CITY OF BOULDER
PLANNING BOARD AGENDA ITEM
MEETING DATE: December 3, 2015

AGENDA TITLE: Public hearing and consideration of an Amendment to Approved Site Plans to amend the approved fencing standards for the TrailCrossing at Lee Hill residential development located at 820 Lee Hill Drive to allow privacy fences in specific areas. The project site is zoned Residential - Low 2 (RL-2). Case No. LUR2015-00094.

SITE REVIEW AMENDMENT to amend a previously approved Site Review application (#LUR2013-00033). Proposal to amend the approved fencing standards for the TrailCrossing at Lee Hill residential development to allow privacy fences in specific areas. The proposal would allow 6-foot cedar privacy fencing on Outlot A, 5-foot solid cedar fencing with 1 foot of latticework above (6 feet total) on Lots 1 and 17 and solid 3'-10" cedar fencing on Lots 18, 24, 25 and 31. Visually permeable 3'-10" high split rail fences would remain in all other locations.

EXHIBIT 1
11.05.15

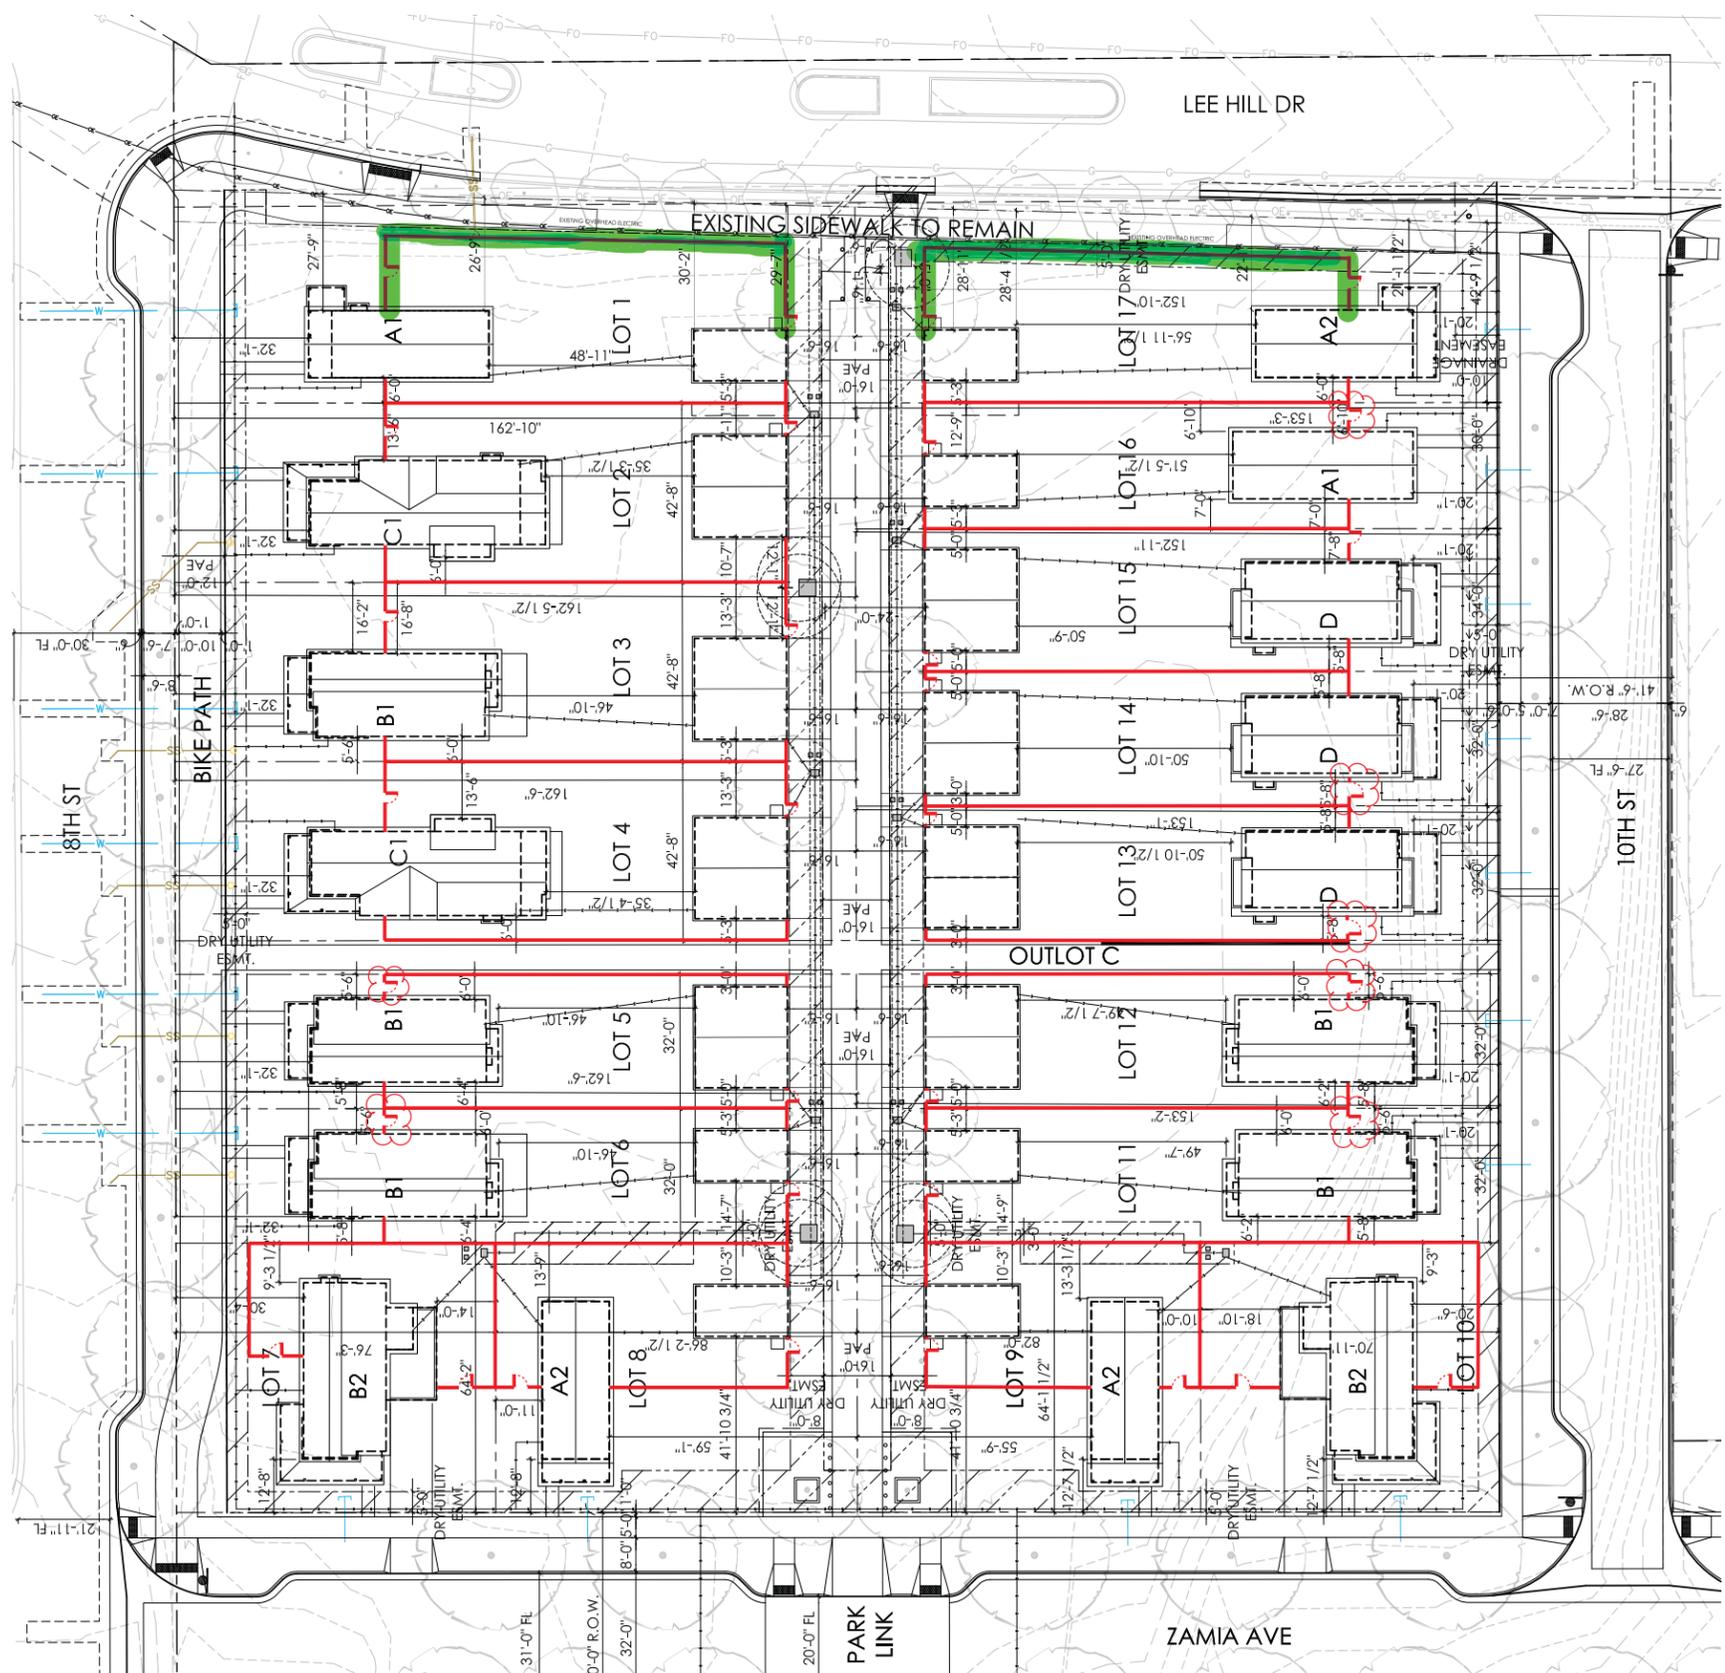
- 3'-10" Open Rail Fence as currently approved (per TEC 2014-00025, dated 8/5/14)
- 6' Solid Cedar Fence
- 5' Solid Cedar Fencing with 1' Lattice detail
- Optional 3'-10" Solid Cedar Fence. Otherwise, 3'-10" Open Rail Fence.

EXHIBIT 2

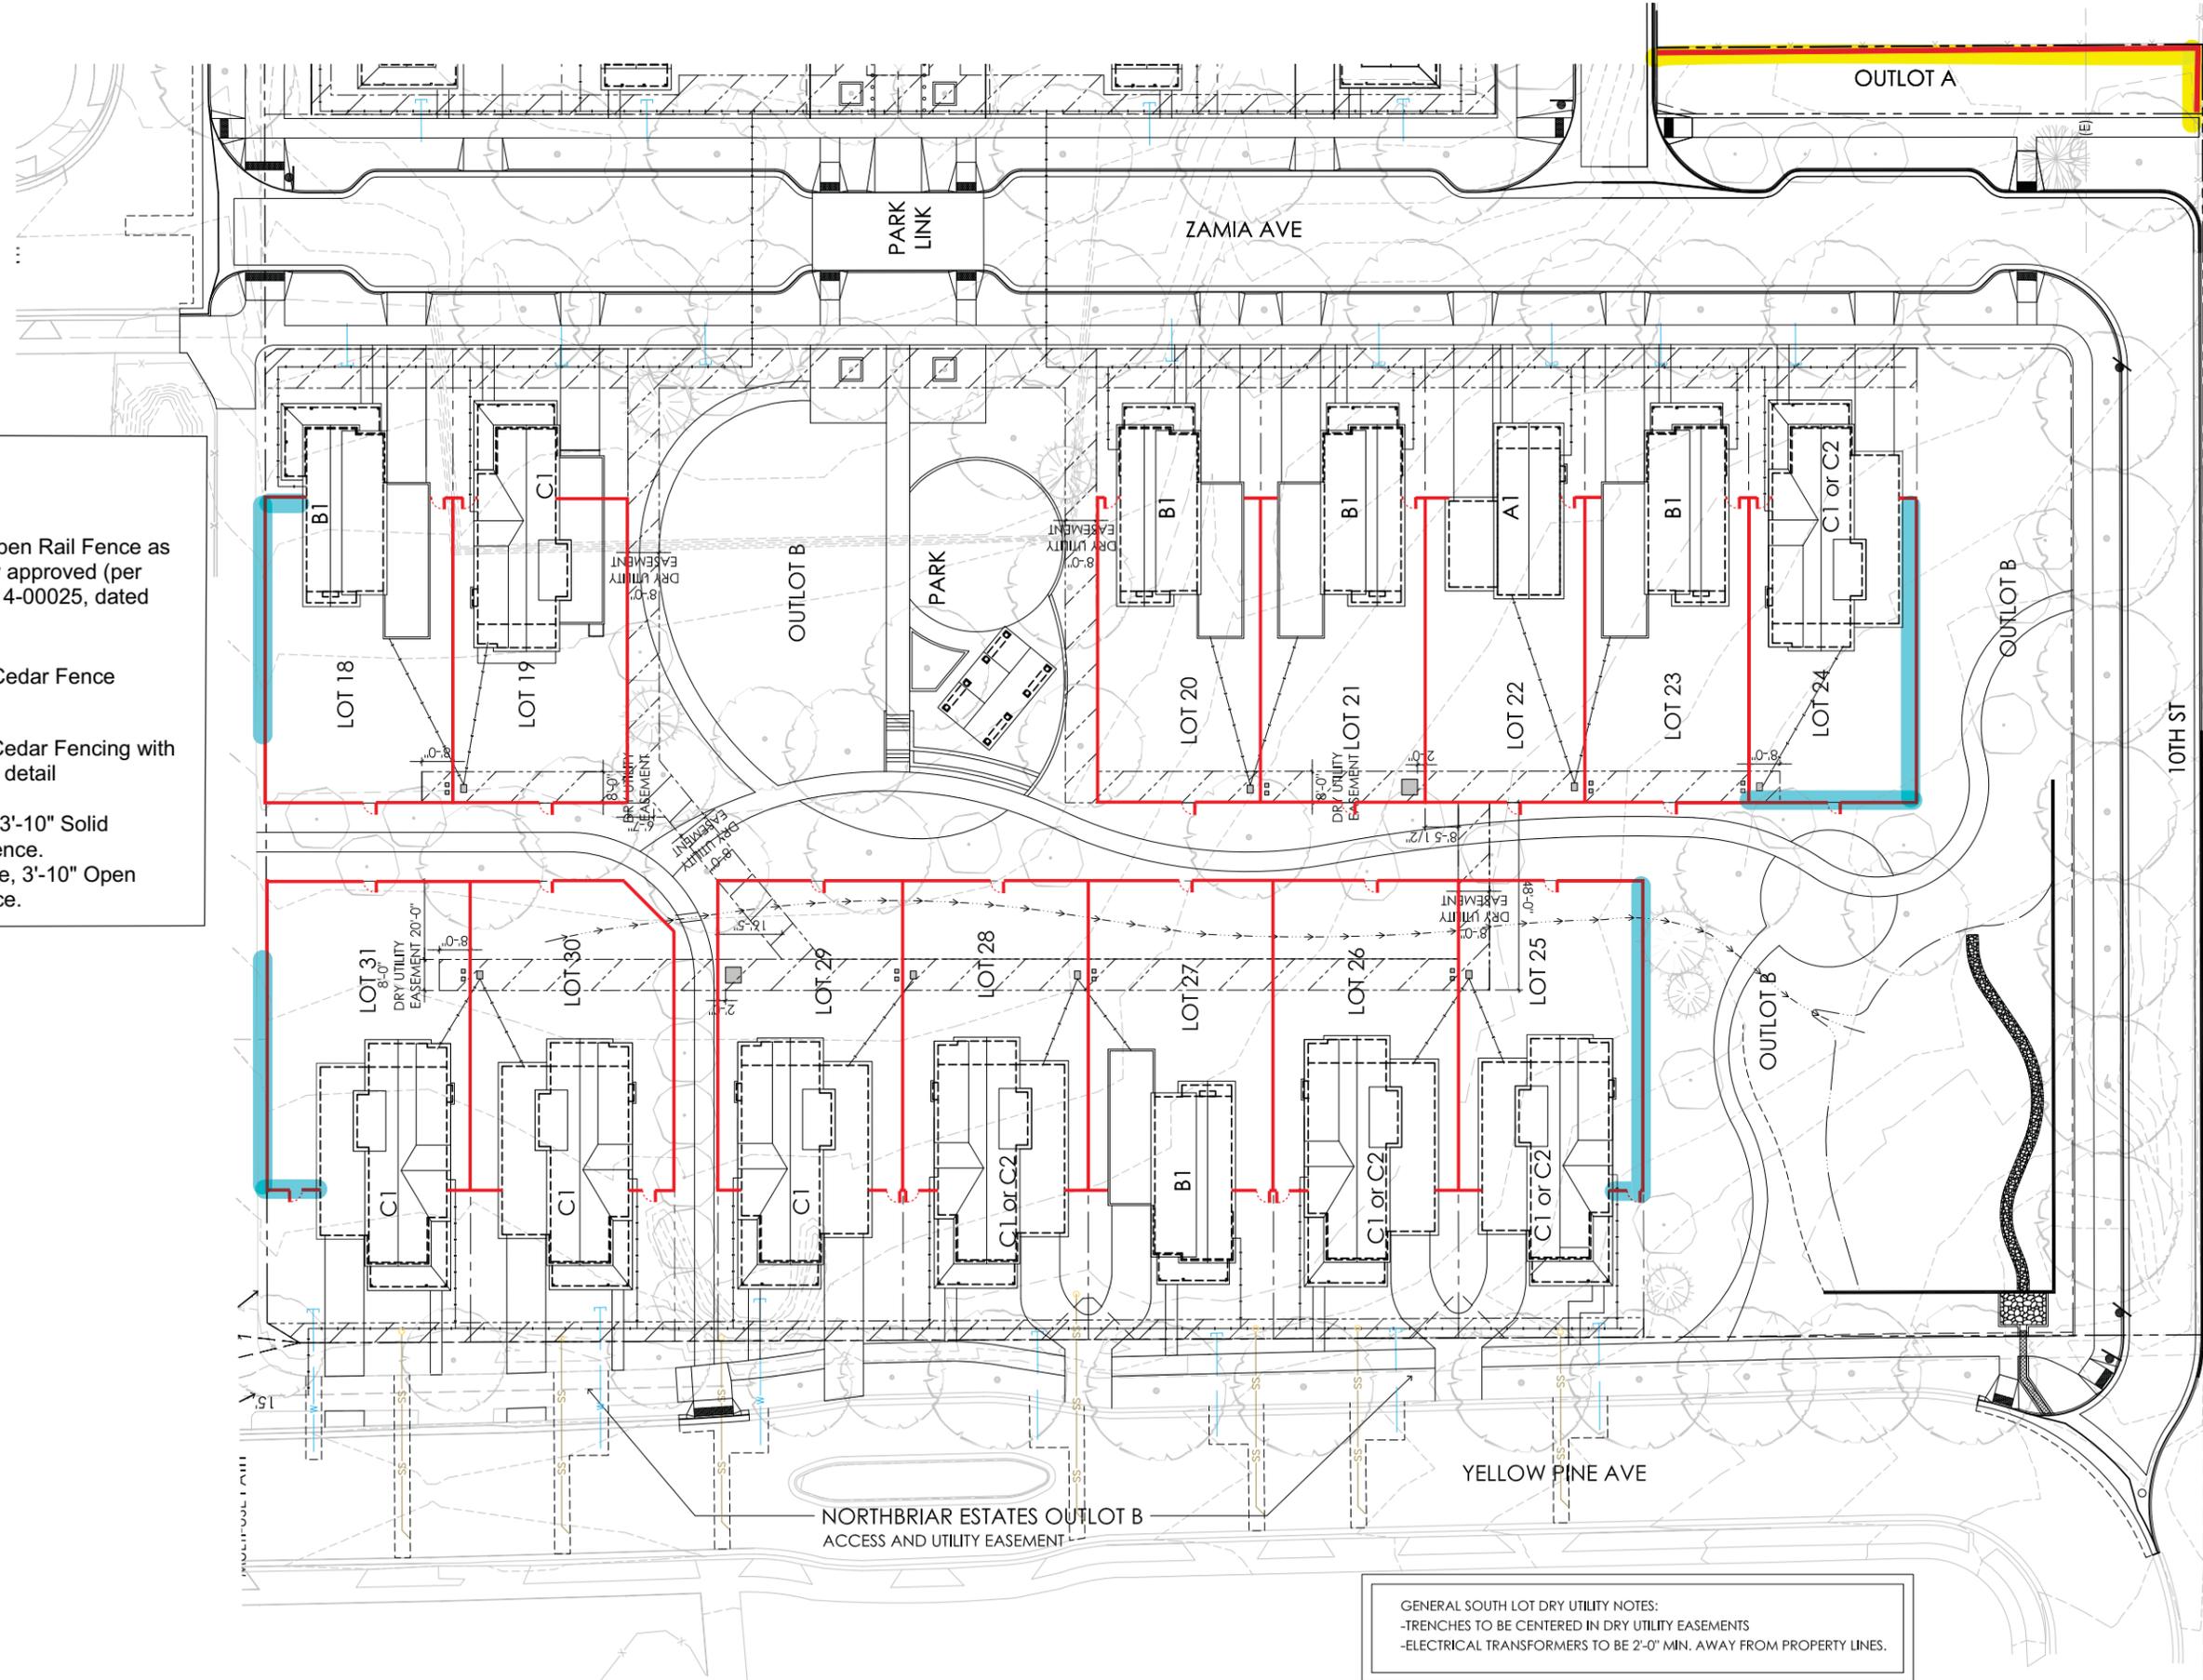
- 3'-10" Open Rail Fence as currently approved (per TEC 2014-00025, dated 8/5/14)
- 6' Solid Cedar Fence
- 5' Solid Cedar Fencing with 1' Lattice detail
- Optional 3'-10" Solid Cedar Fence. Otherwise, 3'-10" Open Rail Fence.

PROPOSED 6' SOLID CEDAR FENCE W/LATTICE DETAIL:

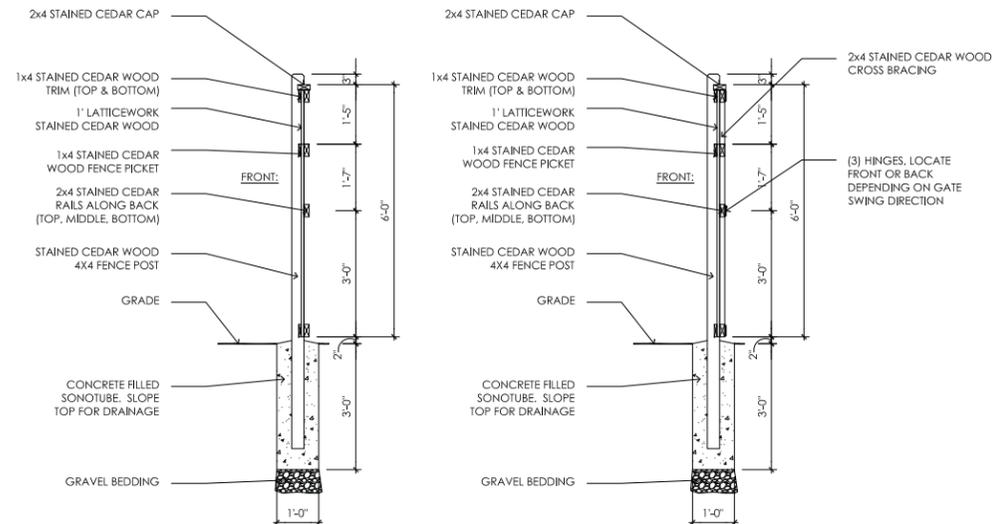
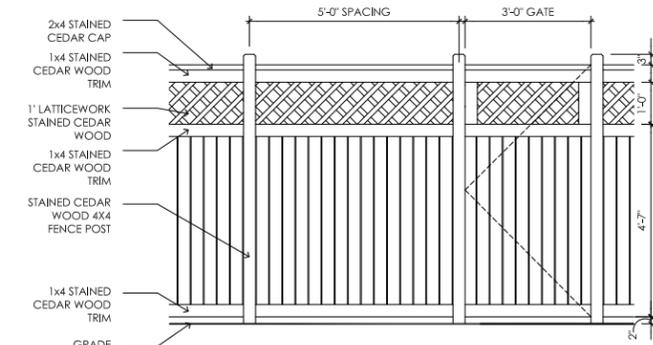
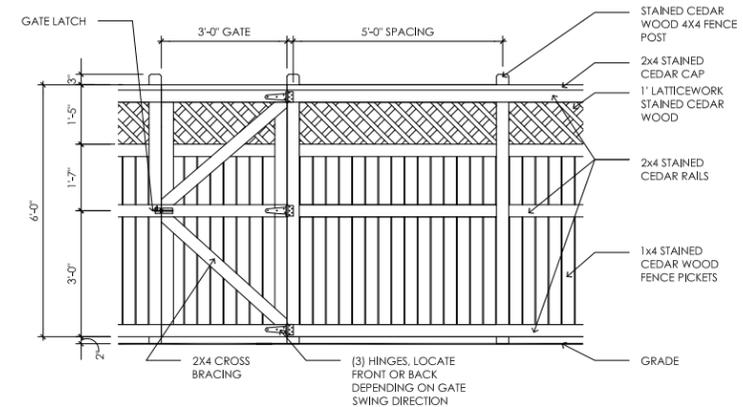
- 5 feet of solid cedar fencing with 1 foot of latticework (6 feet total) at the side and rear yards of Lots 1 and 17 adjacent to Lee Hill Drive;
- 6 foot cedar privacy fences along the north and east boundaries of Outlot A;
- Solid 3 feet-10 inch cedar fencing along a portion of the side yards of Lots 18 and 31 adjacent to the multi-use path, the side yard of Lot 25 and side and rear yard of Lot 24 adjacent to the informal open space;
- 3 feet-10 inch split rail fencing would remain in all other locations, including all front yards.
